## ADDENDUM

NO. 01

**PROJECT NAME:** 2024 Cy Ranch High School Additions And Renovations

**PROJECT NUMBER:** 01818-06-01

AREA D1 - DEMOLITION PLAN - FIRST FLOOR

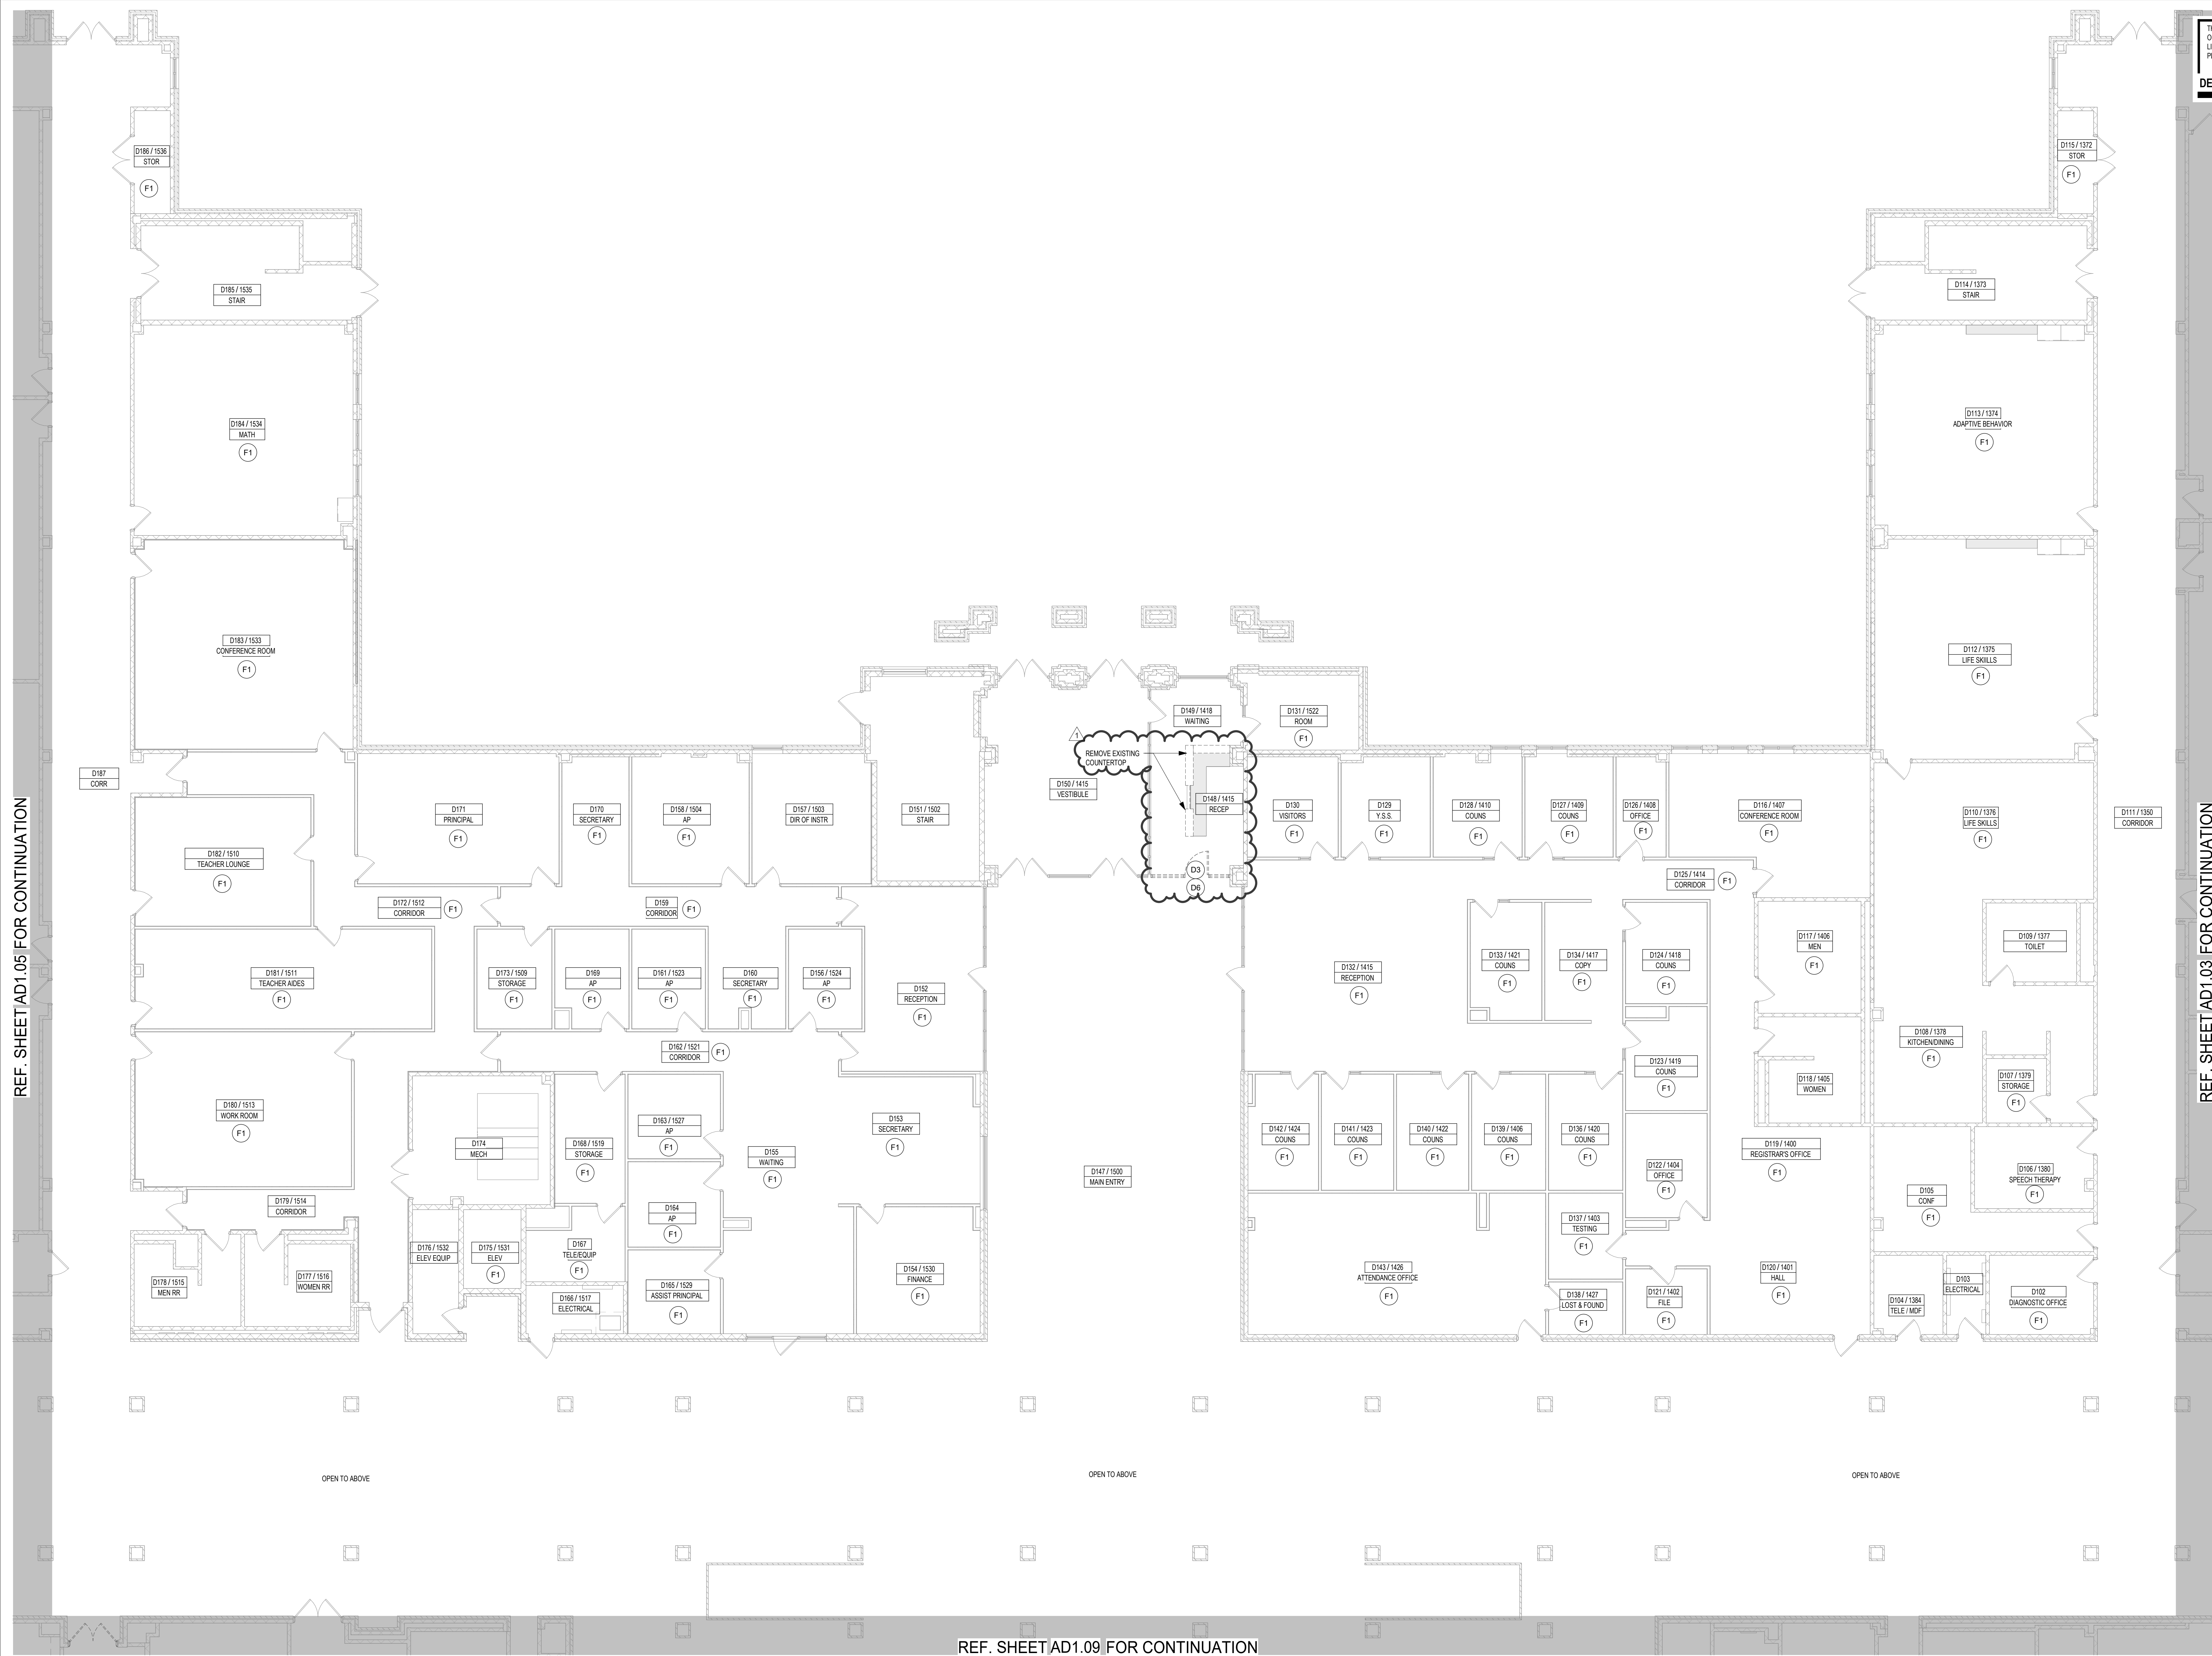
#### **AD No 1, Arch. Item 7: To the Drawings, Sheet AD1.04, "AREA D1 – DEMOLITION PLAN – FRIST FLOOR"**

- 1) Revise demo graphics and notes for D148 Reception per attached sheet

- 2) Add existing reception glazing and door to be removed per attached sheet

1 AREA F1 - FIRST FLOOR DEMOLITION PLAN  
1/8" = 1'-0"

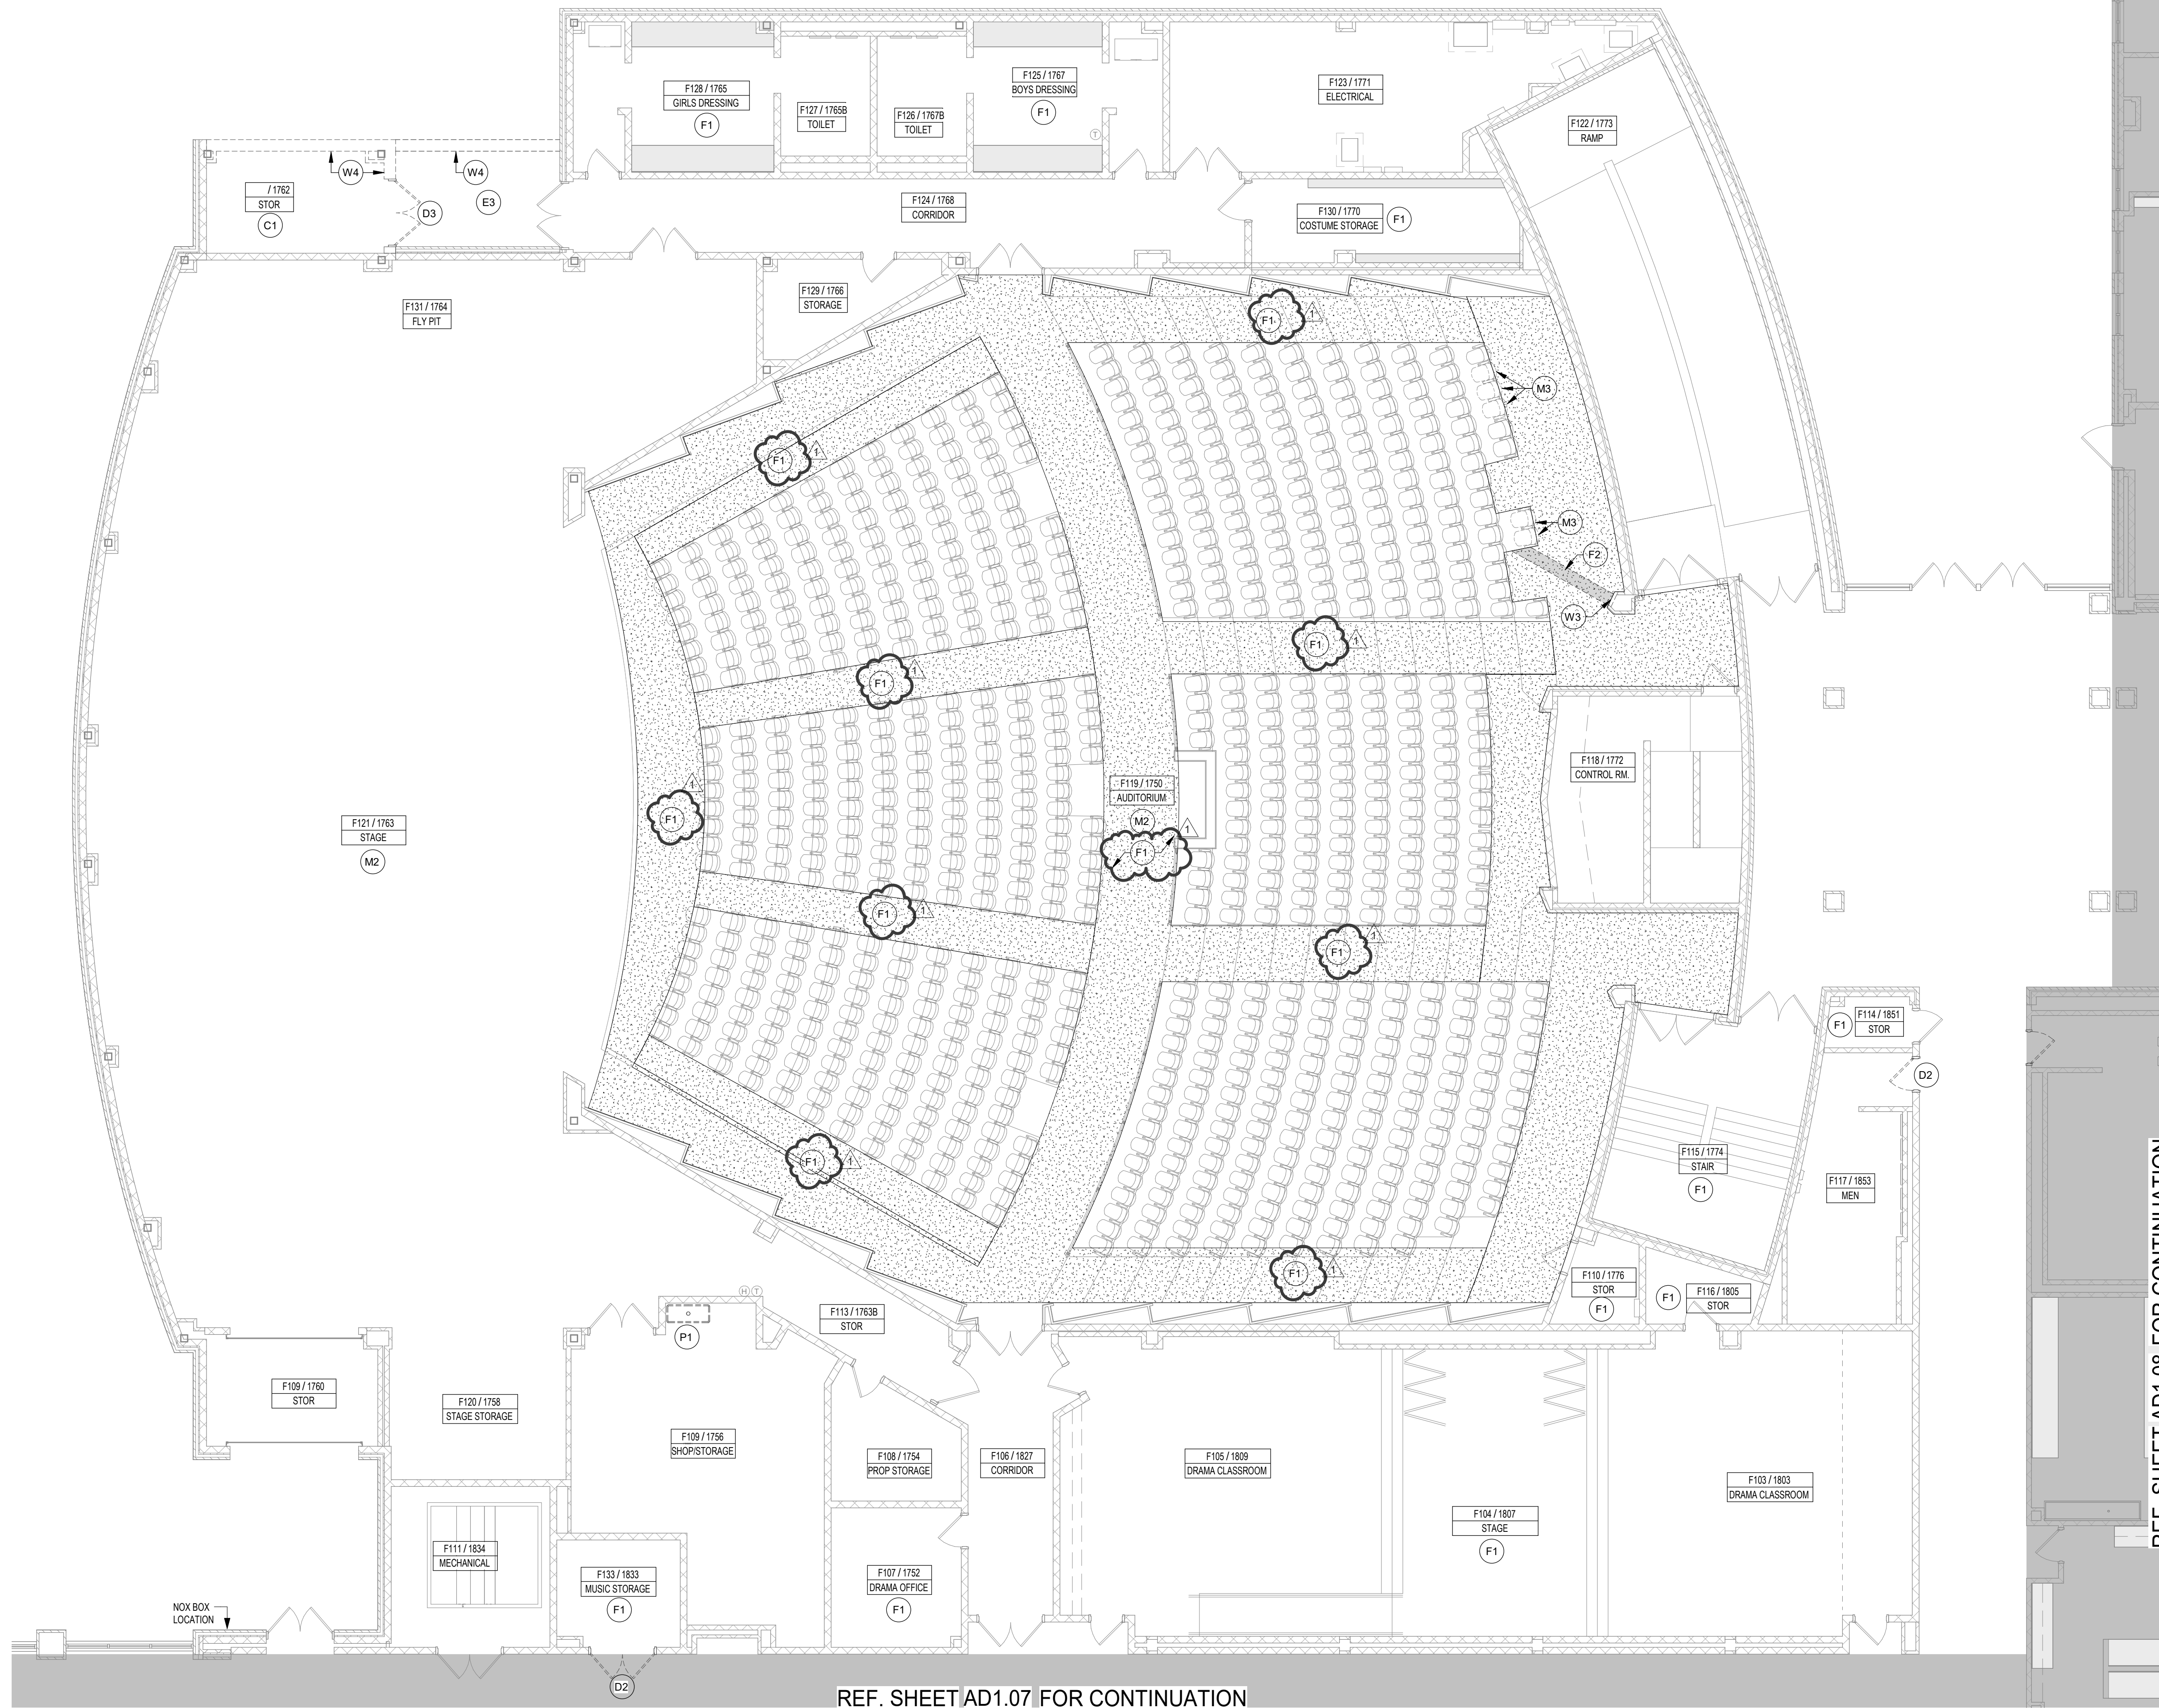
**AD No 1, Arch. Item 8: To the Drawings, Sheet AD1.06, "AREA F1 – DEMOLITION PLAN – FRIST FLOOR"**

- 1) Revise demo notes for F119 Auditorium per attached sheet

**AREA G1 - DEMOLITION PLAN - FIRST FLOOR**

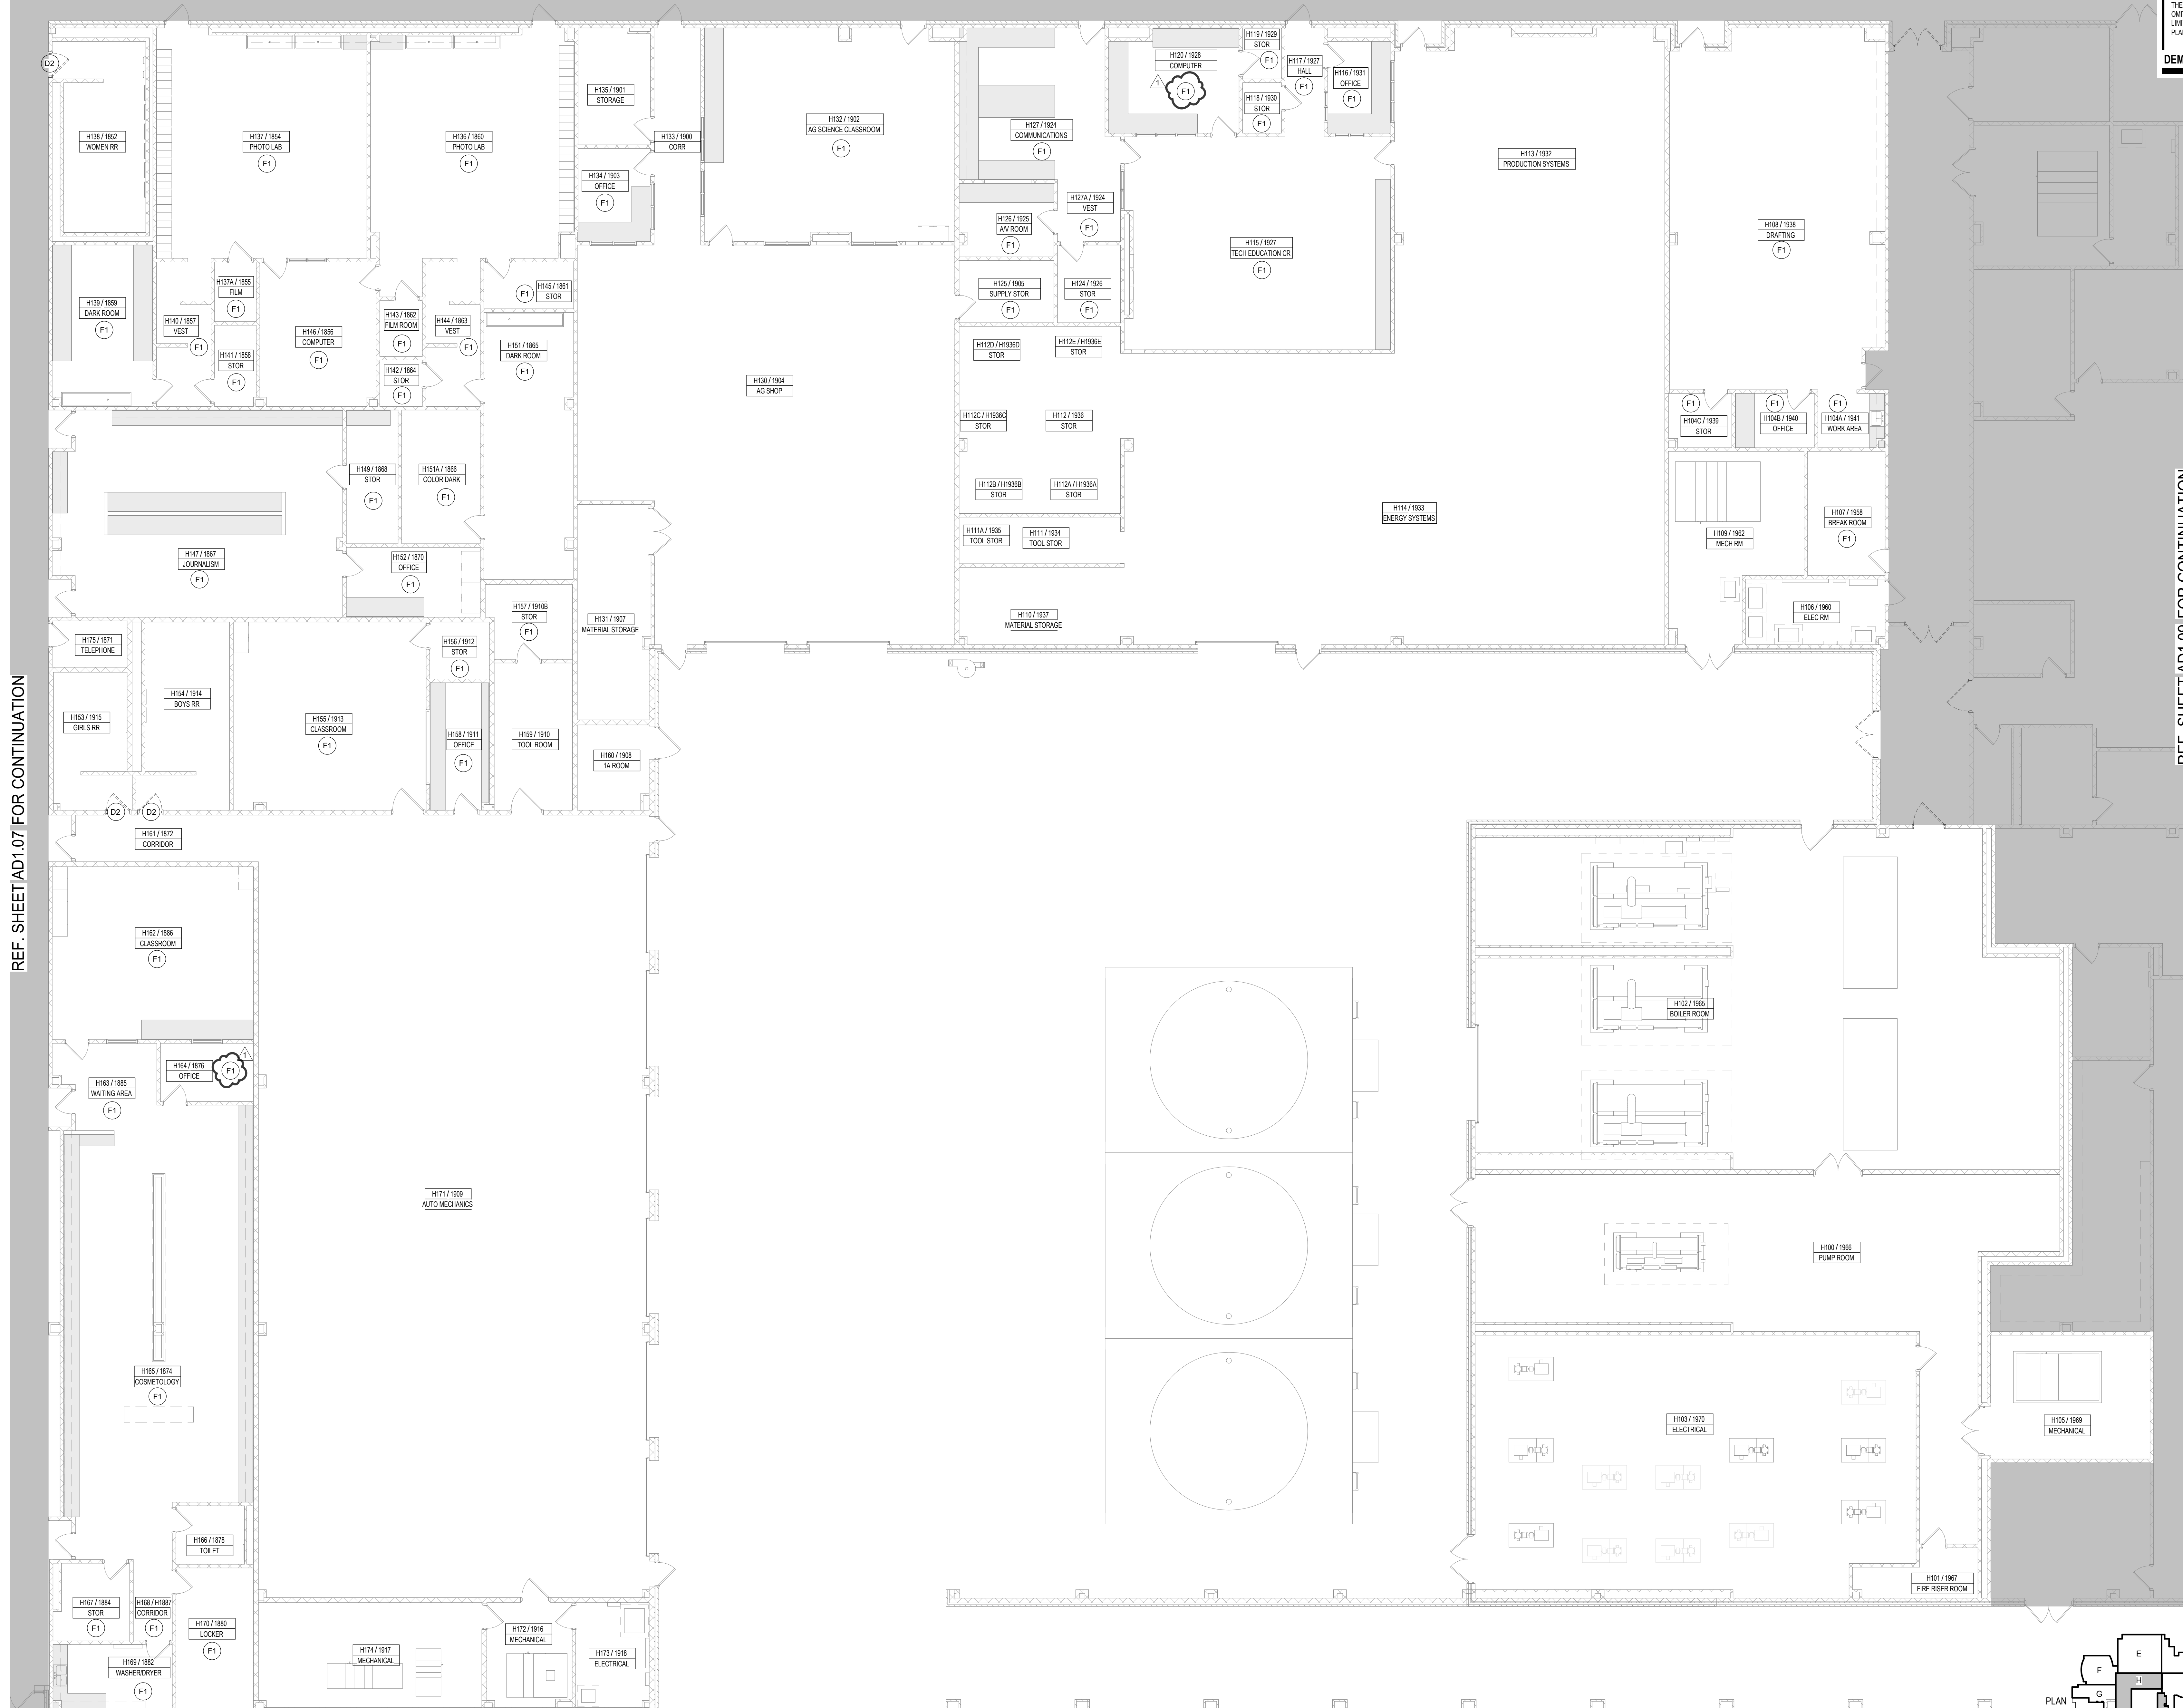
**AD No 1, Arch. Item 9: To the Drawings, Sheet AD1.07, "AREA G1 – DEMOLITION PLAN – FRIST FLOOR"**

- 1) Revise demo notes for existing kiln and storage rooms per attached sheet
